FOR PERCOLATION TESTING AND SITE EVALUATION

SUBDIVISION/PROPERTY NAME Hermanstorfer Property LOT NO. N/A

PROPERTY ADDRESS 4013 New Cut Road Ellicott City
STREET TOWN/POST OFFICE

RE: Hermanstorfer Property
Site Development Plan Application
DPZ File No. SDP-07-052

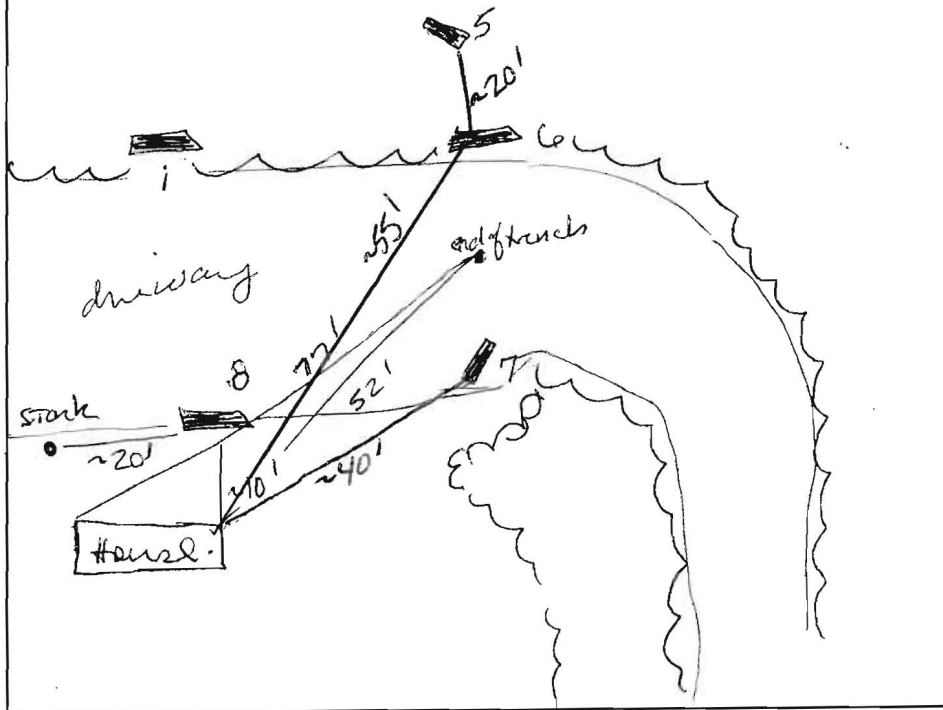
REMARKS: Holes dug per plan #3 not dug #5 visual observation; field
 SANITARIAN: SF/AT/RB BACKHOE: OTHERS:
 TEST HOLES USED IN SDA: AVG. PERC TIME: SQ. FT/BR:
 TRENCH WIDTH: INLET DEPTH: MAX. BOT DEPTH: EFFECTIVE SM:
 pretreatment potential
 #2 inlet @ 4' existing trench located ~ middle of driveway?

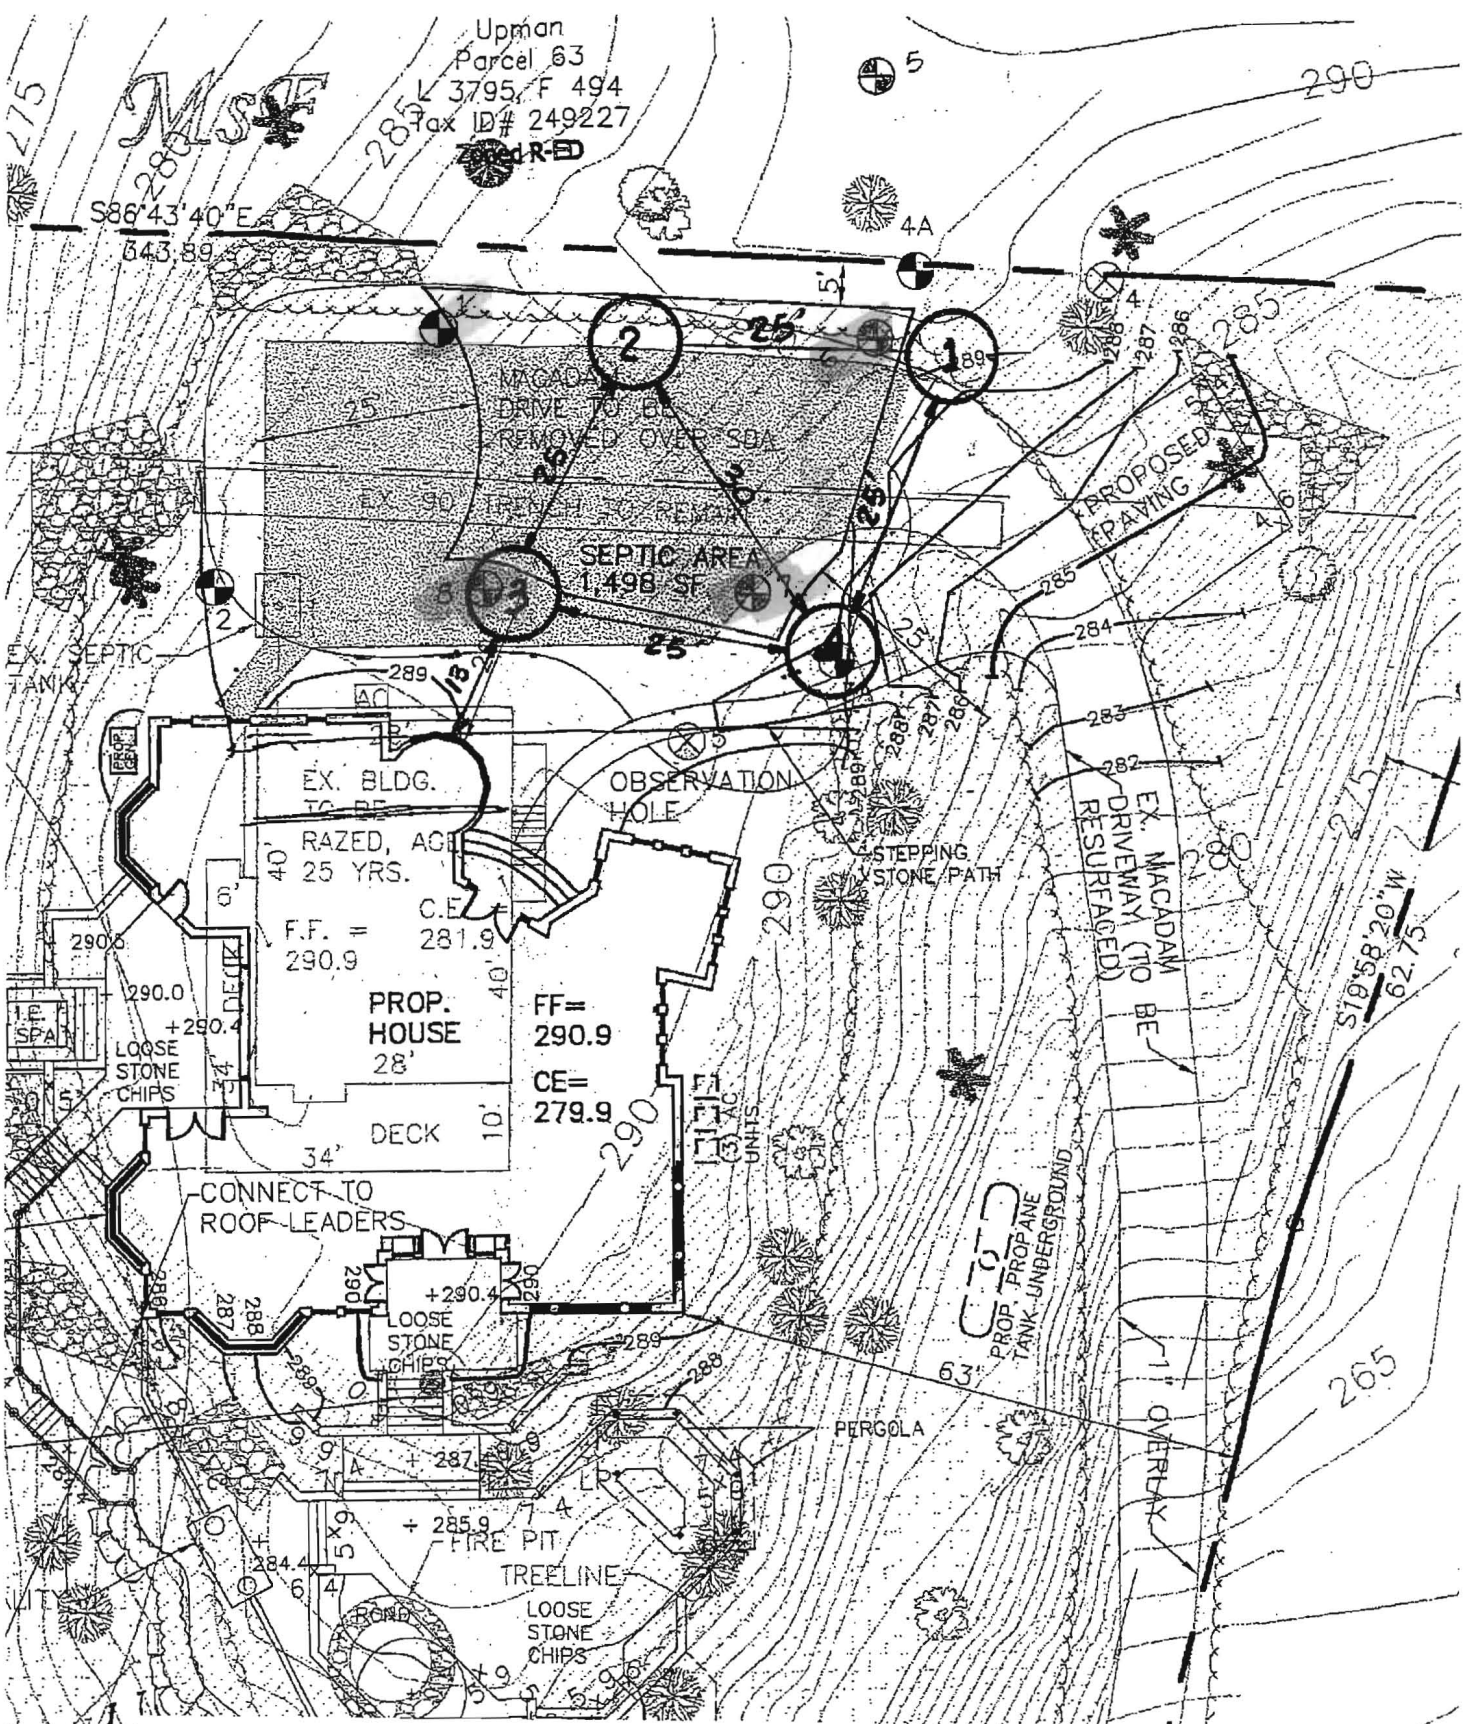
REMARKS holes staked in field by engineer *redug to go deeper original holes*
 SANITARIAN _____ BACKHOE Hatfields OTHERS K. wheelbarger
 TEST HOLES USED IN SDA _____ AVG. PERC TIME _____ SQ. FT/BR _____
 TRENCH WIDTH _____ INLET DEPTH _____ MAX. BOT DEPTH _____ EFFECTIVE SW _____
to support dry wells
